Memorandum

Date: July 10, 2025
To: Stephen Siri, Martin Mariner Square, LLC
From: Sam Tabibnia, Fehr and Peers
Subject: 2433 Mariner Square Drive Project – Site Access and Circulation Review

OK24-2433

SITE PLAN - GRADE

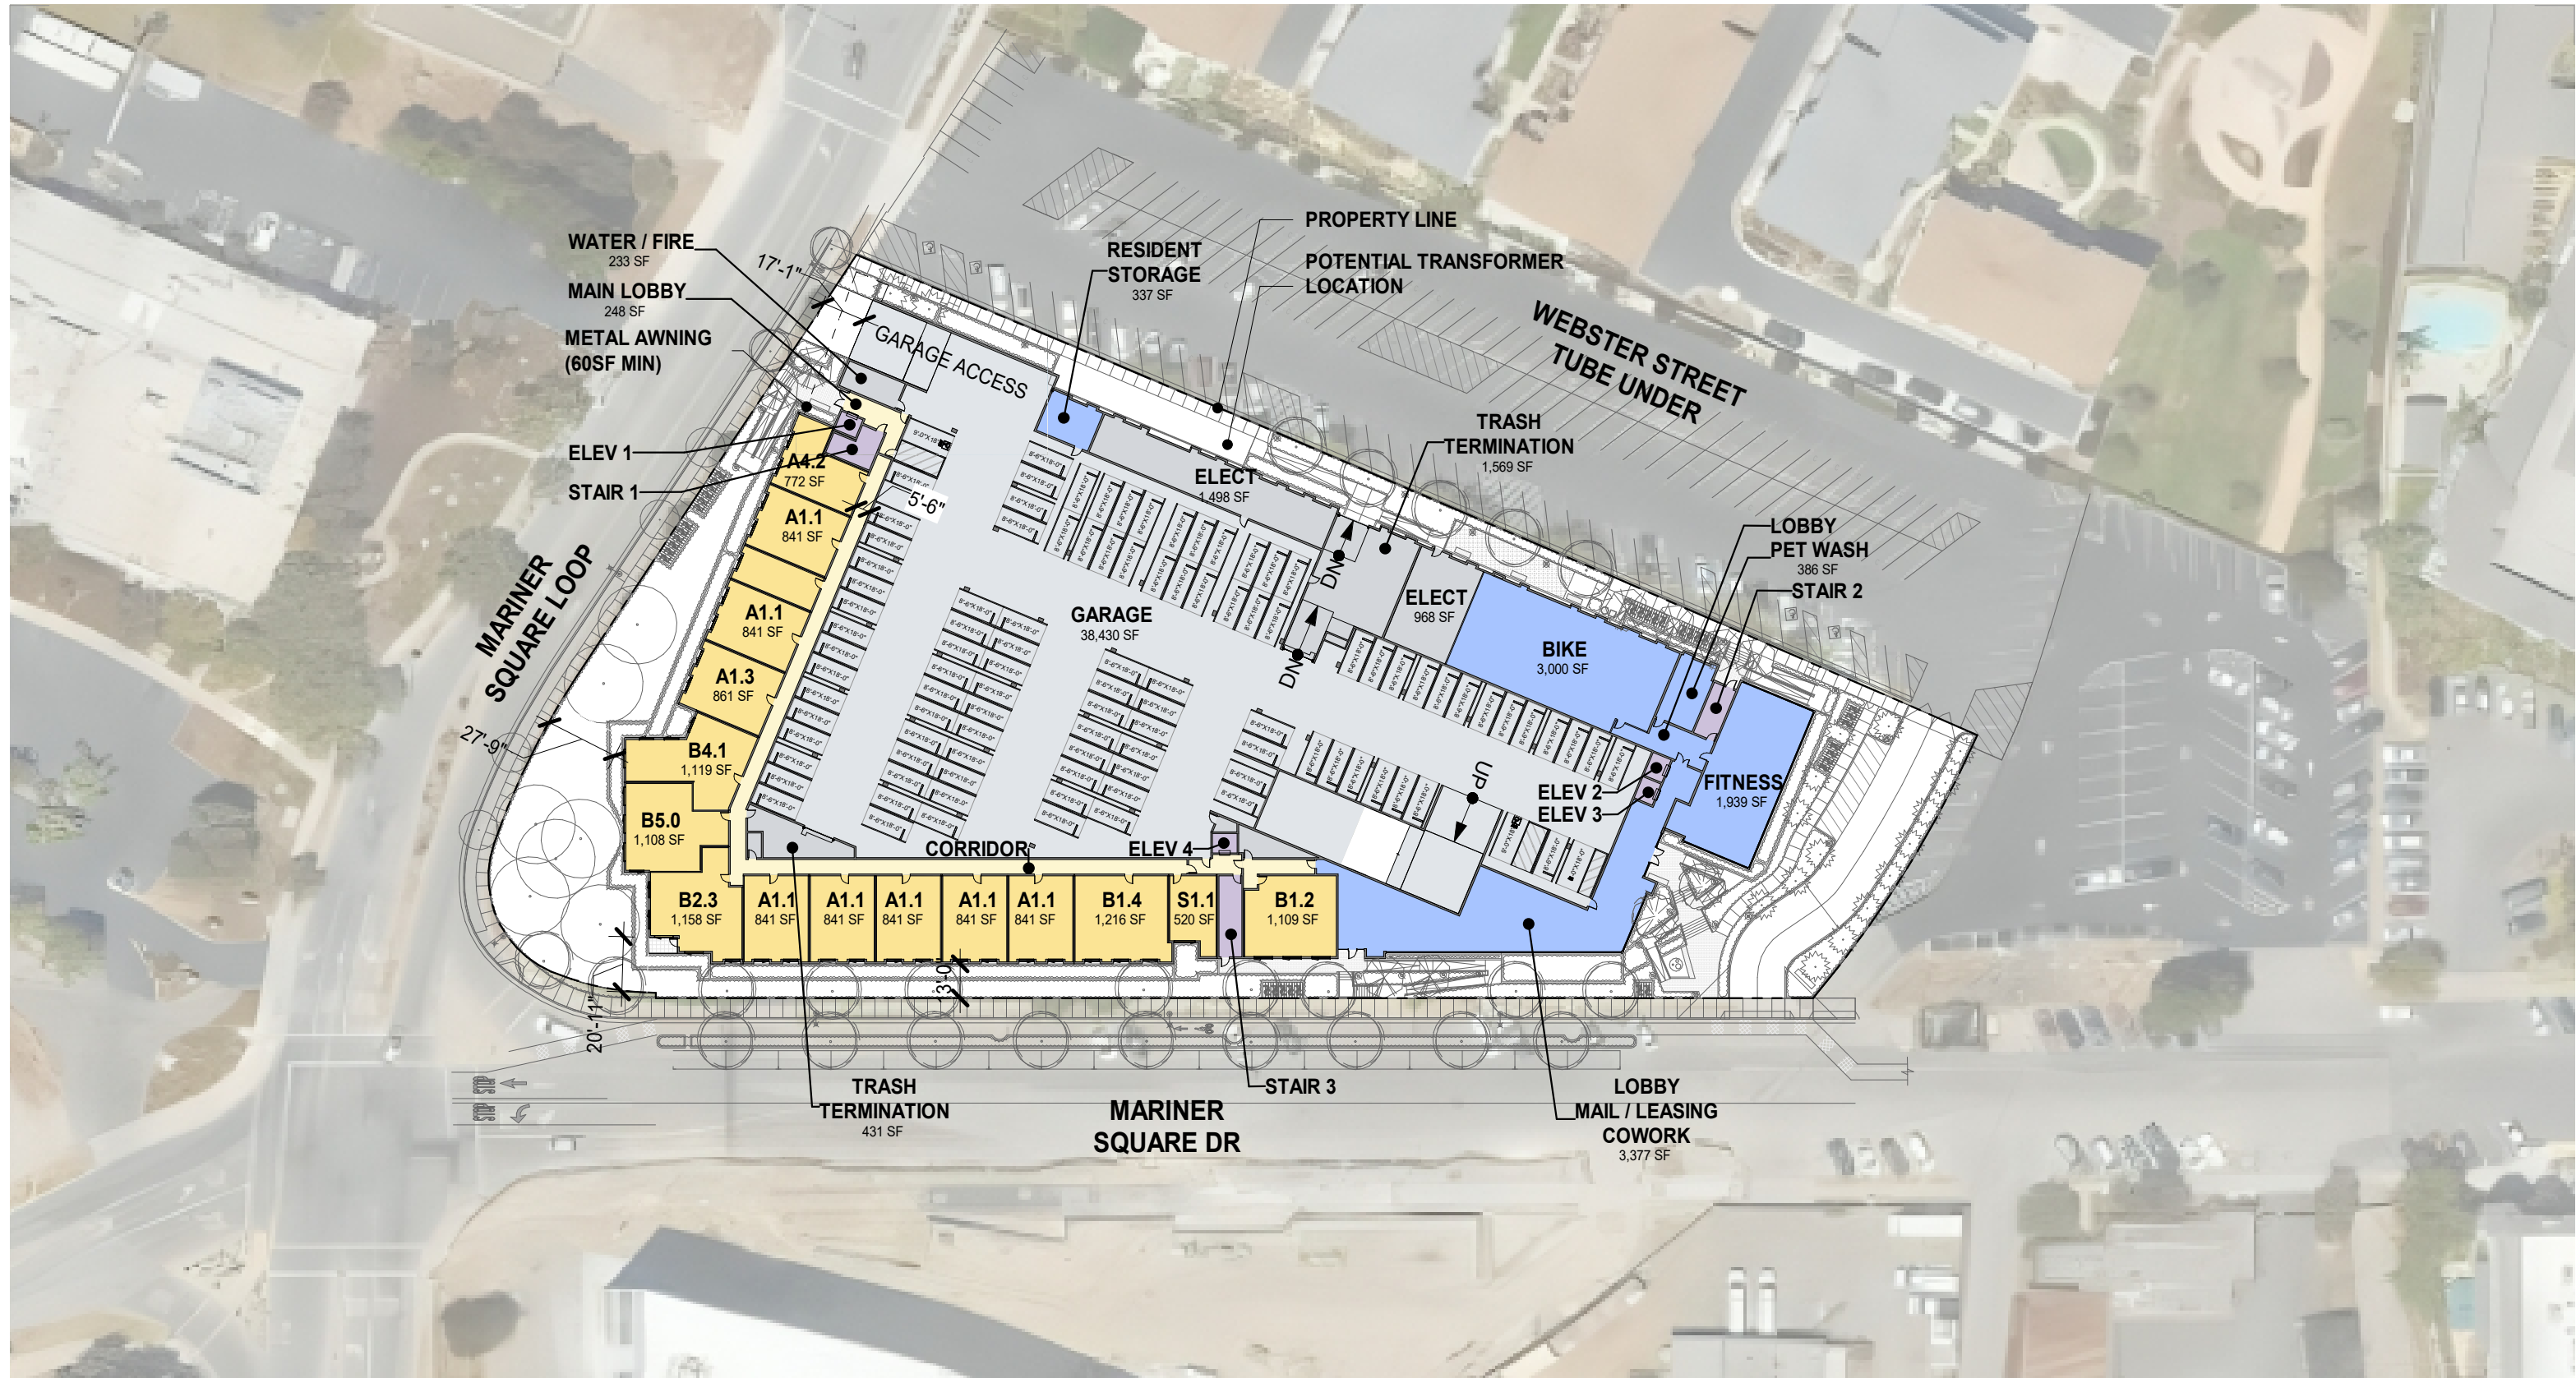
Based on a review of the Project site plan, the three Project driveways would provide adequate sight distance between exiting motorists and pedestrians on the adjacent sidewalk on each side of each driveway.¹

The proposed garage driveway and the existing Caltrans lot driveway on Mariner Square Loop would be within 70 feet of the intersection with Mitchell Avenue. The proximity of the two driveways to each other and to the adjacent signalized intersection could result in vehicles waiting to turn left from eastbound Mariner Square Loop into either driveway to queue on eastbound Mariner Square Loop and spill back into the intersection. In addition, vehicles turning left out of either driveway may have limited sight distance to eastbound Mariner Square Loop. Therefore, it is recommended that both driveways on Mariner Square Loop be limited to right-in/right-out only through installation of a physical median barrier.

Recommendation 1: Consider constructing a physical barrier, such as a narrow, raised median with soft-hit posts, on Mariner Square Loop extending for about 100 feet east of the signalized intersection to prohibit left-turns into and out of the Project driveways on Mariner Square Loop.

The implementation of a median on Mariner Square Loop per Recommendation 1 would result in vehicles wanting to turn left into or out of the surface lot to use the driveway on Mariner Square Drive. Vehicles wanting to turn left into or out of the garage may need to take circuitous routes. Accommodating U-turns on eastbound Mariner Square Loop at the Mariner Square Drive/Mariner Square Loop/Marina Village Parkway intersection would improve access for vehicles approaching the garage from eastbound Mariner Square Loop or Mitchell Avenue.

Recommendation 2: Consider one of the following at the Mariner Square Drive/Mariner Square Loop/Marina Village Parkway intersection to accommodate U-turns on eastbound Mariner Square Loop:

- Provide fair-share contribution to convert the intersection from all-way stop-controlled to a roundabout
- Modify the eastbound intersection approach to accommodate U-Turns (coordinate with Recommendation 3 which recommends removing the porkchop island at the northwest corner of the intersection)

intersection require multiple crossings by pedestrians. Thus, removing the porkchop island would reduce the pedestrian crossing distance at the intersection.

Recommendation 3: At the Mariner Square Drive/Mariner Square Loop/Marina Village Parkway intersection, consider removing the southbound right-turn lane and the adjacent porkchop island.
